**U.S. NUCLEAR REGULATORY COMMISSION**  
 In the Matter of AmerGen Energy Co. LLC  
 Docket No. 50-029-42 Official Exhibit No. Exh. 39  
 OFFERED by: Applicant/ AmerGen  
 NRC: \_\_\_\_\_  
 IDENTIFIED on 9/14/07 KA N/A  
 Action Taken: ADMITTED REJECTED WITHDRAWN  
 Reported/Class: Kaufman, TX 75142 DW  
Eq: 072 022 3047

**Memorandum**

**Subject: Further Discussion of the Nature of the Corroded Surfaces and  
The Residual Wall Thickness of the Oyster Creek Dry Well**

**Figure 1**

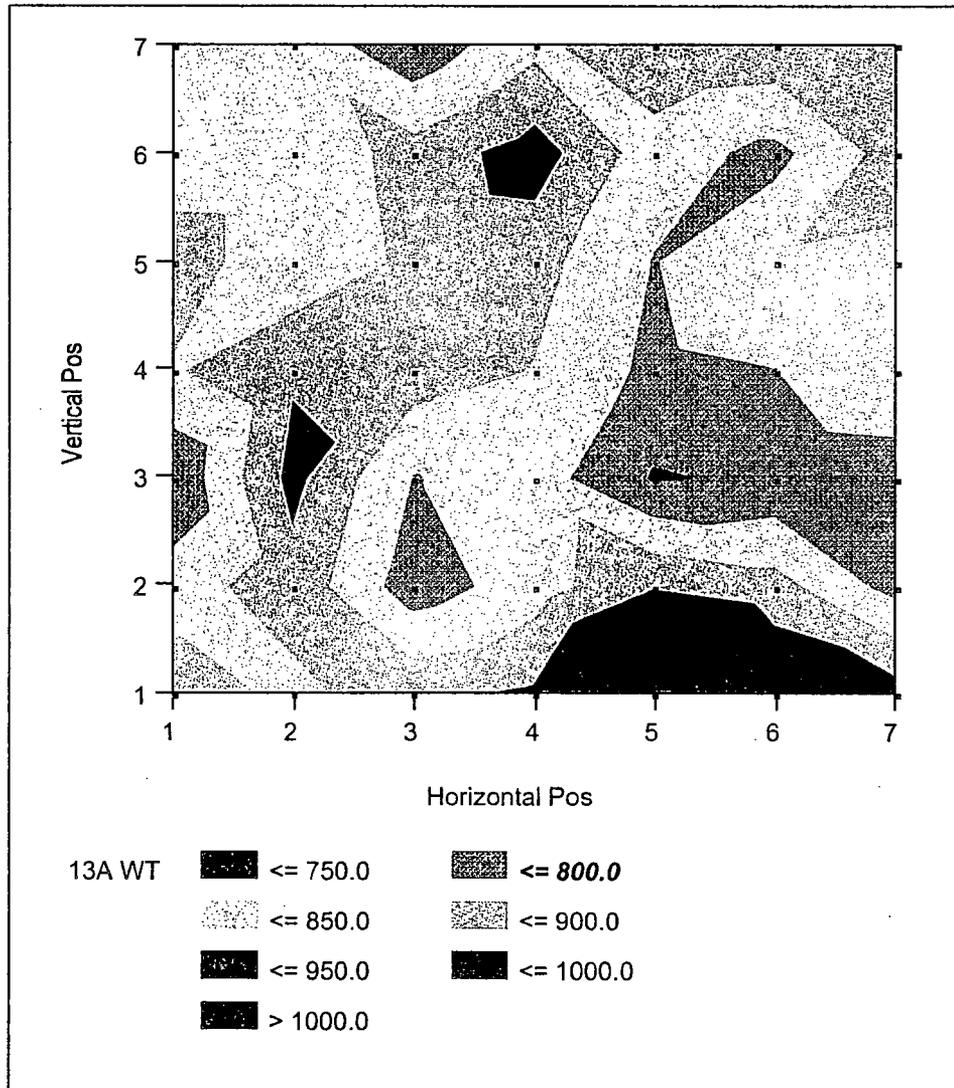
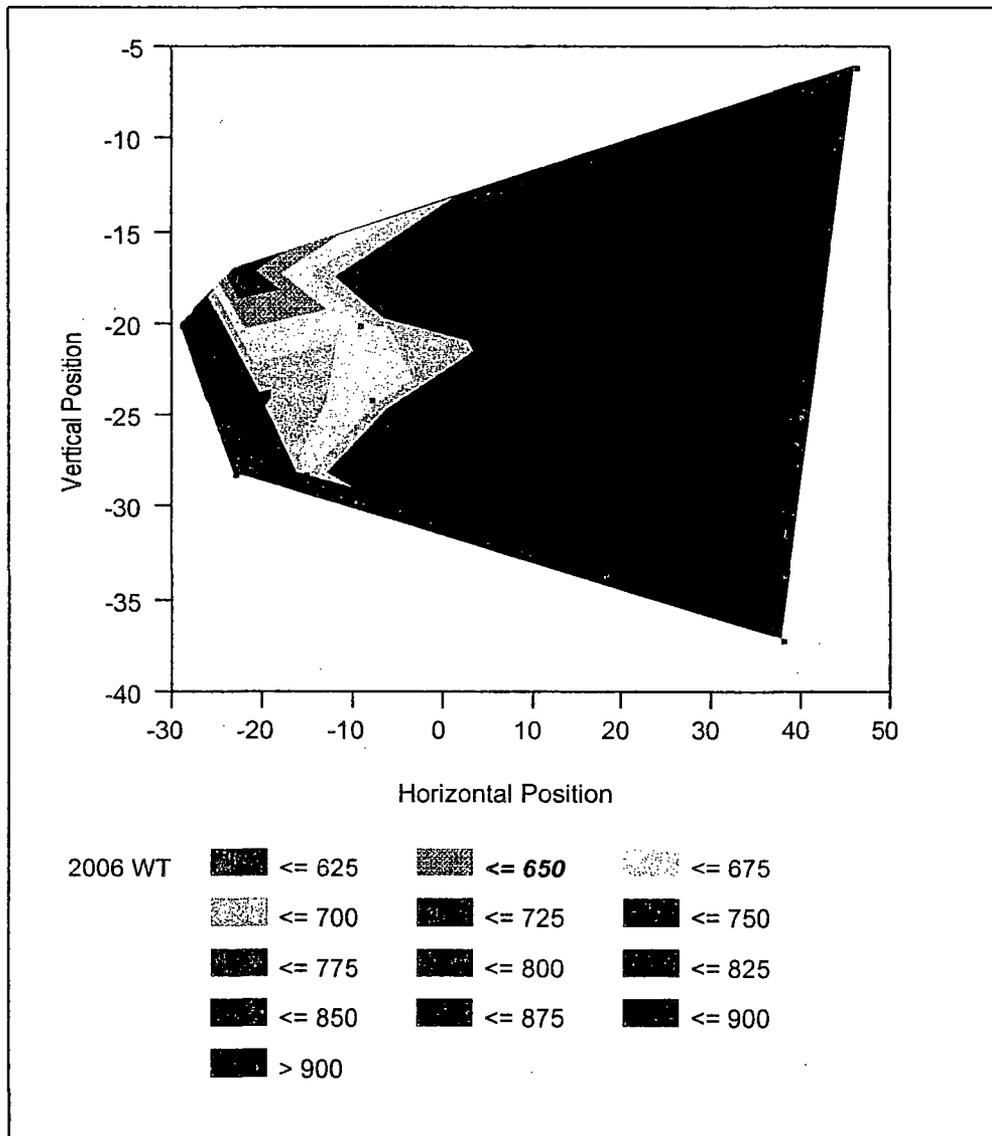
- That because of the location of the internal grid measurements they are not representative of the overall corrosion damage (as discussed above). This is demonstrated by way of an example in Figures 1 and 2 for Bay 13.
- That for Bay 1, where only a strip grid was used for internal UT measurements (1 inch by 7 inch for only 7 UT locations), the results returned by the internal measurements in no way reflect the overall corrosion in that Bay<sup>25)</sup>
- That therefore the external UT measurements have to be used for the assessment of the severity of corrosion and the residual margins.

**Figure 3**

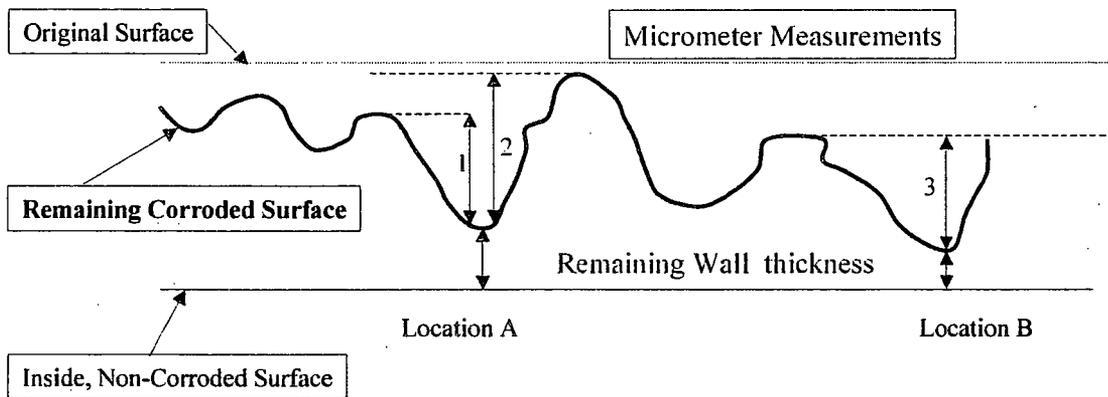
There is no guarantee, nor was this discussed at all, that the reference point for the UT measurement and the micrometer measurement are the same. As Figure 3 suggest, the reference can be high or low. Finally, adding the micrometer measurement to the UT measurement might have made some sense if the sum were to reflect the original wall thickness where upon the roughness could have been subtracted to indicate a possible correction. This was however not the case since in addition to pitting there was general reduction of wall thickness. (This is supported by the description of the “bathtub ring”).

- Location A:** Since the remaining, corroded surface is “dimpled”, the *Micrometer Measurement* clearly depends on the point of reference. However, the point of reference is not, cannot be, the *Original Surface*, hence the *Micrometer Measurement* is in no relationship to the remaining wall thickness.
- Location B:** Here the “Pit Depth” obtained by micrometer measurement (3) is smaller than (2) in location A but the remaining wall thickness here is the least. Visual observation would identify Location B as less corroded because visually one has no reference point, in particular, one cannot refer back to the original surface area.

**Figure 4**

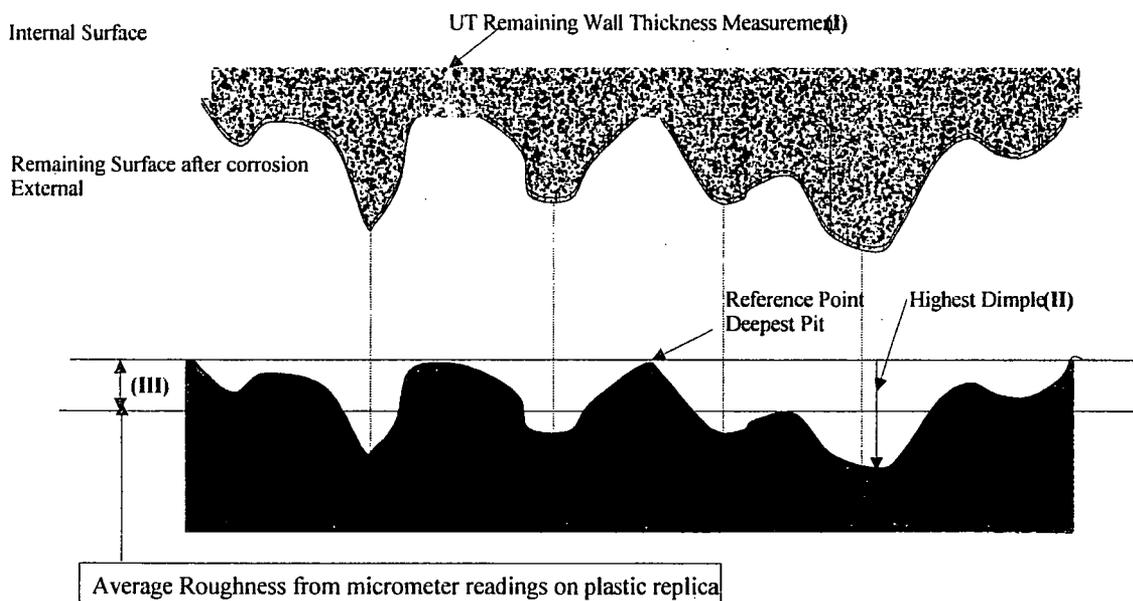
- **Figure 4** shows a schematic of the epoxy imprint of the remaining corroded surface. On that epoxy surface replica 20 micrometer measurements of the "pit depth" were made in order to characterize the roughness of the surface.

(Note that the replica was actually a negative of the surface. Therefore each depression on the replica related to a raised area on the surface. The twenty measurements were averaged and the standard deviation calculated. This was done for both replicas. It turns out that there is no statistical difference between the average micrometer readings from both replicas, hence a grand average and pooled variance could be calculated. The average “roughness” (dimple height) is 125 mils with a pooled standard deviation of 70 mils. This number reflects the average variation in height from valley to peak and in essence characterizes the roughness of the surface.

**Figure 5**

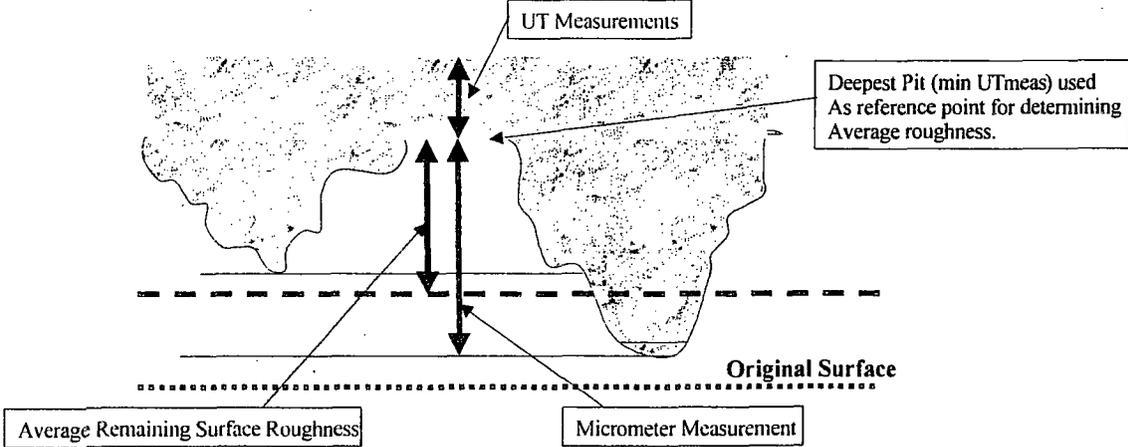
- **Figure 5** shows how the average roughness correction is being used to correct the UT measurements. The UT measurements reflect the residual wall thickness (UT). Additionally micrometer measurements were made at each location where a UT measurement had been performed. Now the UT result and the micrometer result are added and the average roughness is subtracted from the sum in order to obtain the so called “*evaluation thickness*”. It is observed that with this correction every UT measurement, except for one, which had been below 736 mil is moved to above 736 mils and therefore into the acceptable range.

- In discussing this procedure one has to remember that the correction was made because the UT measurement was said to be inaccurate because of the air gap between the probe and the metal surface caused by the inherent roughness. Now it was never established to what extent the accuracy of the UT measurement suffered because of this air gap. Did it over- or underestimate the remaining wall thickness? Similarly, the micrometer measurement is affected by the roughness of the remaining surface as well.

- This entire procedure is extremely fraught with uncertainties. There is the perceived uncertainty of the UT measurement, never established but postulated. There is the uncertainty of the micrometer measurements, and then there is the correction for which there does not seem to be a justification.

- Therefore, the evaluation thickness should be disregarded (as has been done at times) in favor of the actual measurements.
